**Fire Protection Upgrades
Halifax Elementary School
464 Plymouth Street
Halifax, MA 02338**

**Habeeb & Associates Architects
H&A Job No. 1614.01**

**ADDENDUM NO. 03
February 4, 2019**

ATTIC SECTIONS

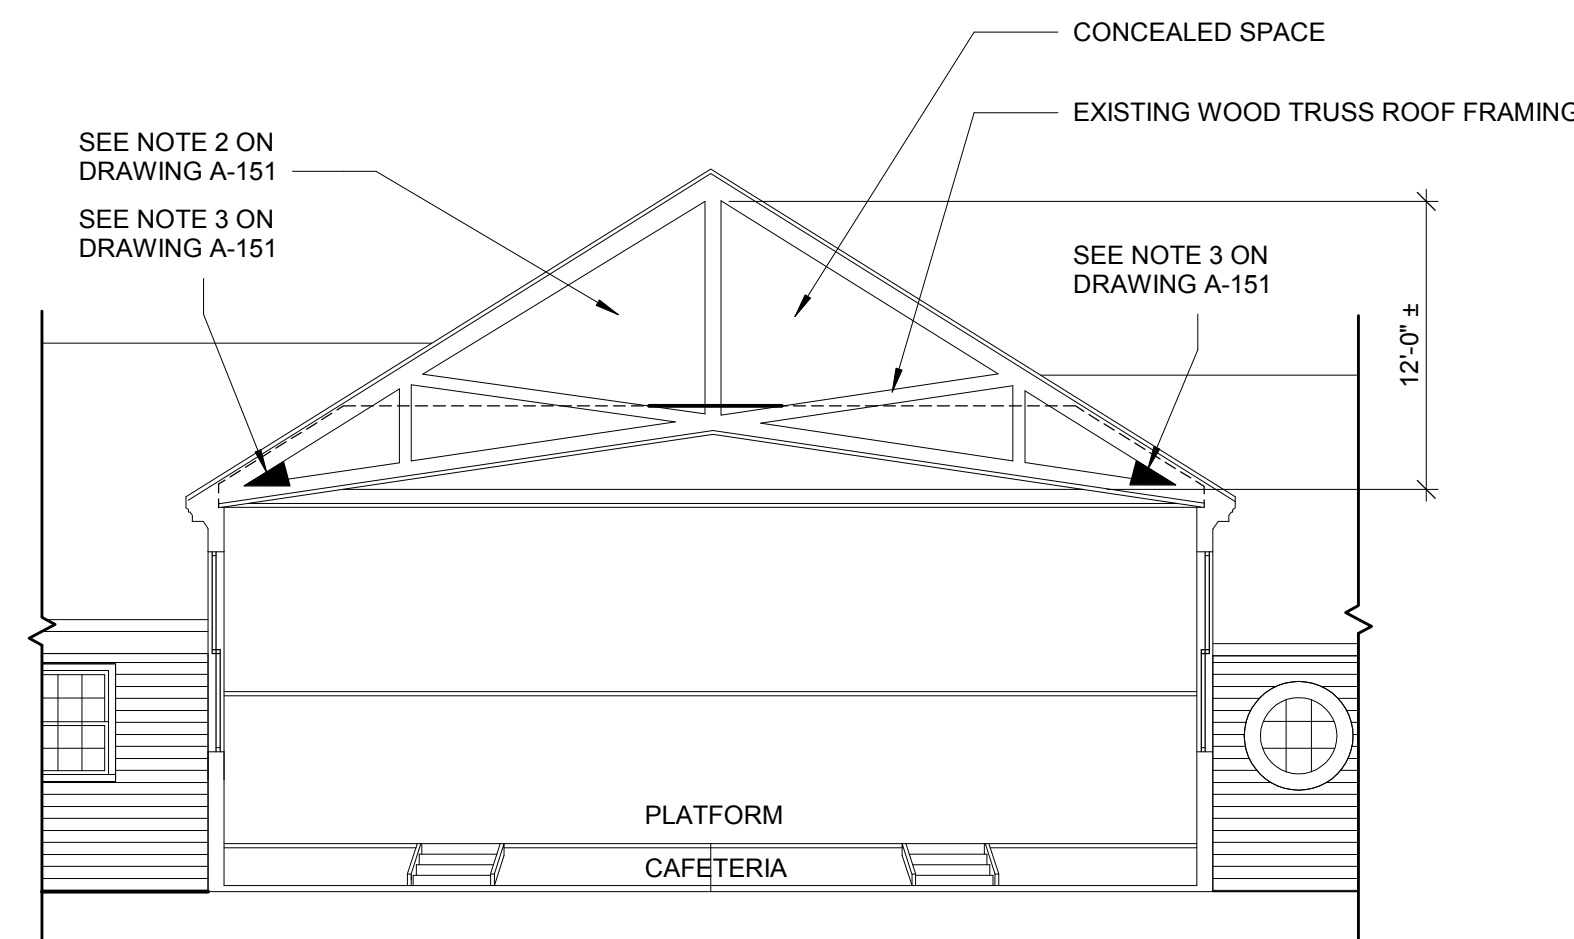
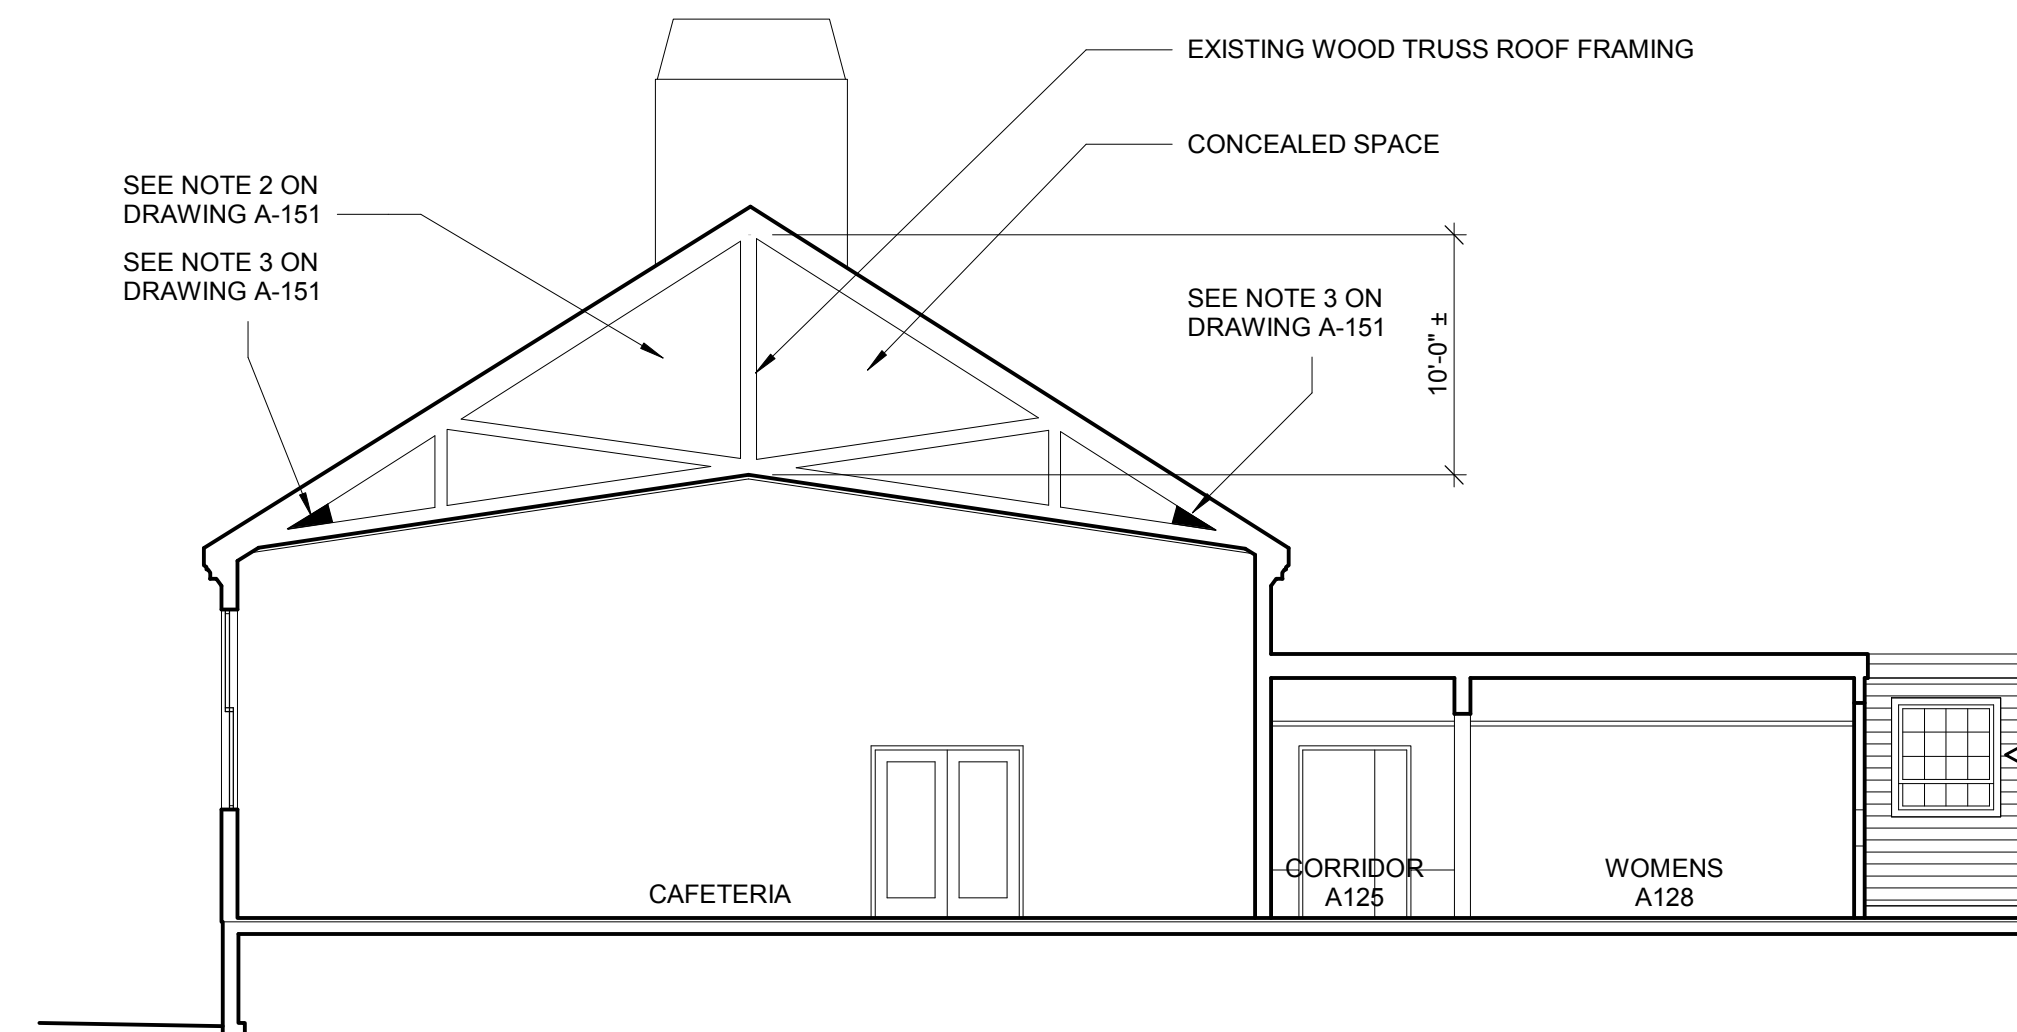
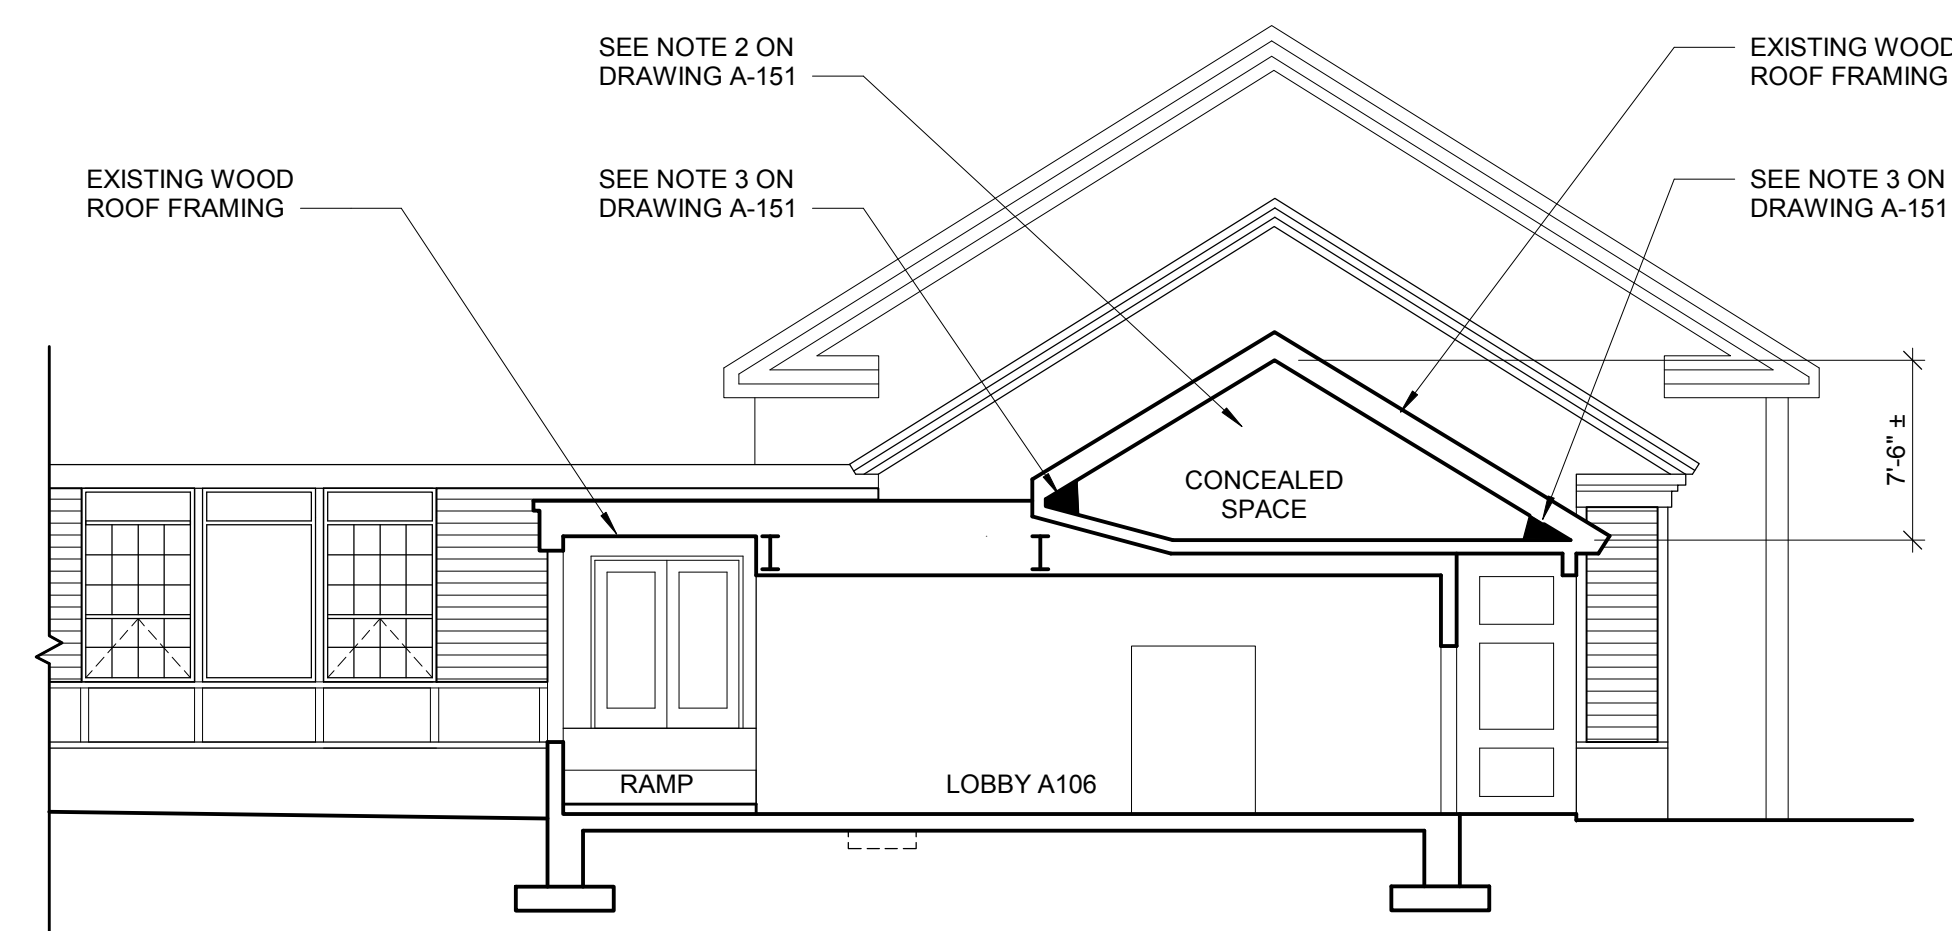
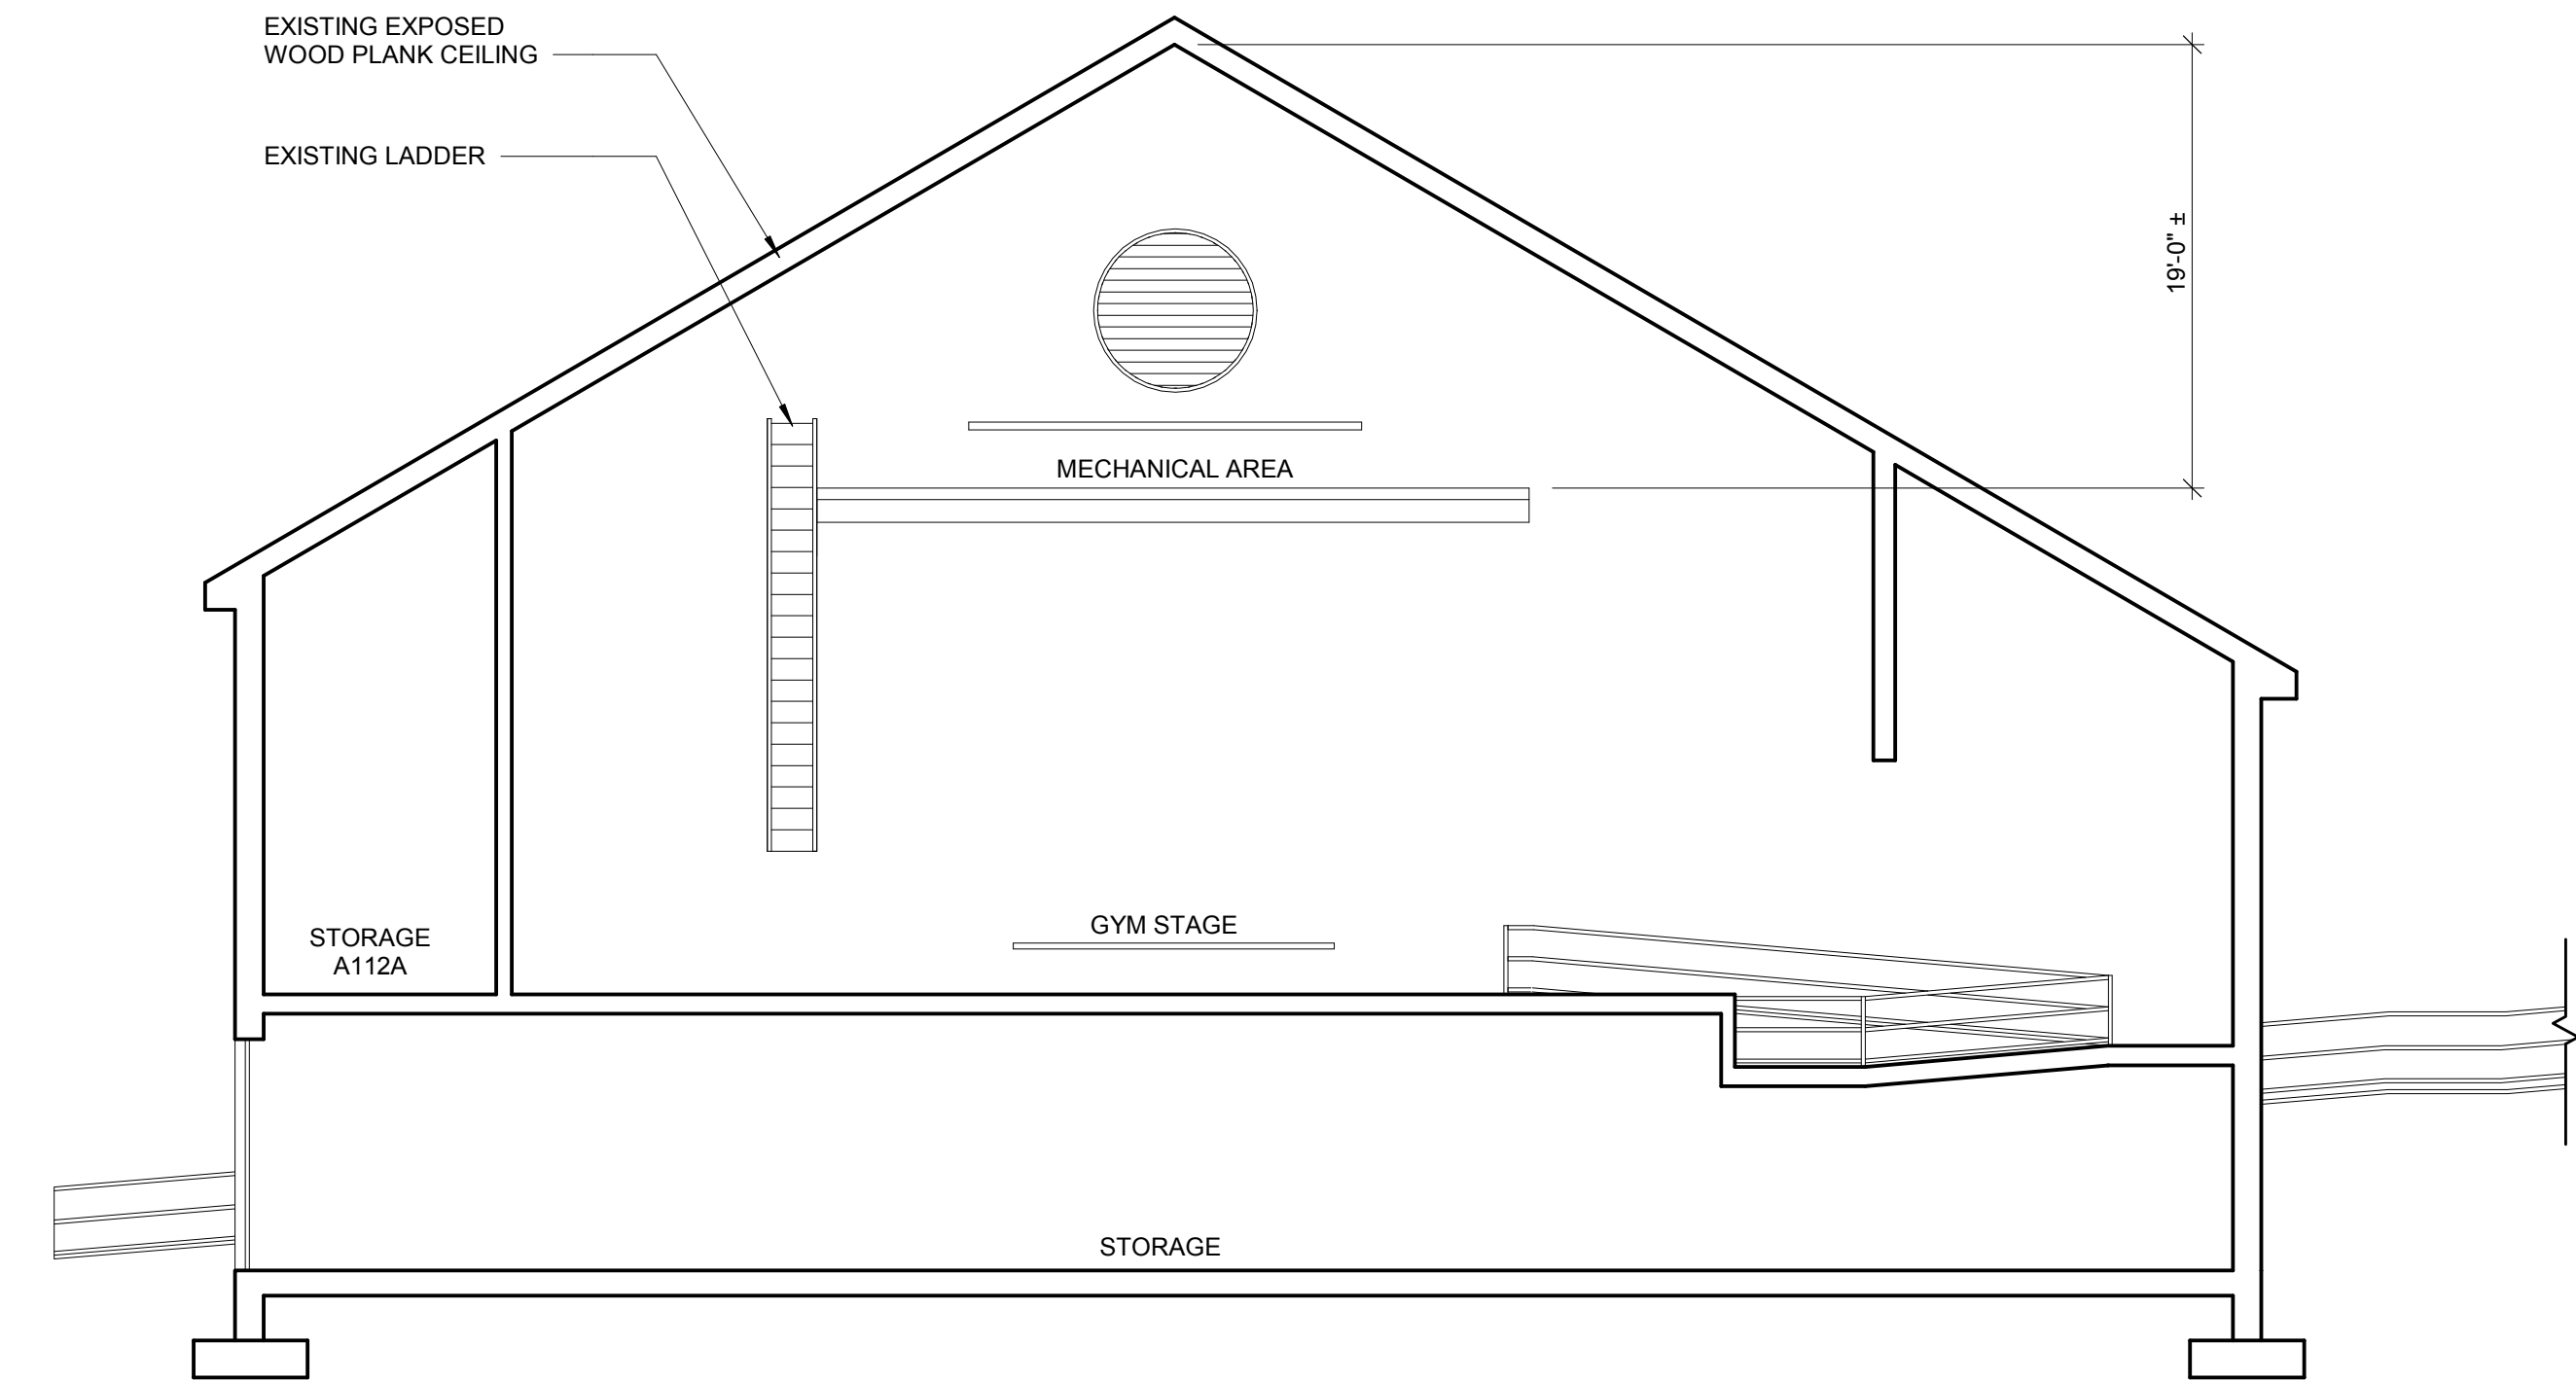
4. **QUESTION:** Regarding the comment highlighted in yellow in Sheet Number A-300 ATTIC SECTIONS, are we to understand that the whole roof is not to be sprayed, that only the small black triangular areas are to be sprayed? If so then is it the foam in SPECIFICATION 2.02 or SPECIFICATION 2.03? Additionally what is the R-VALUE and what are the dimensions for installation of this foam?

RESPONSE: The whole roof does not need to be sprayed. Just the areas along the eaves shown in the black triangular areas and as shown on the attached sketch SK-1.
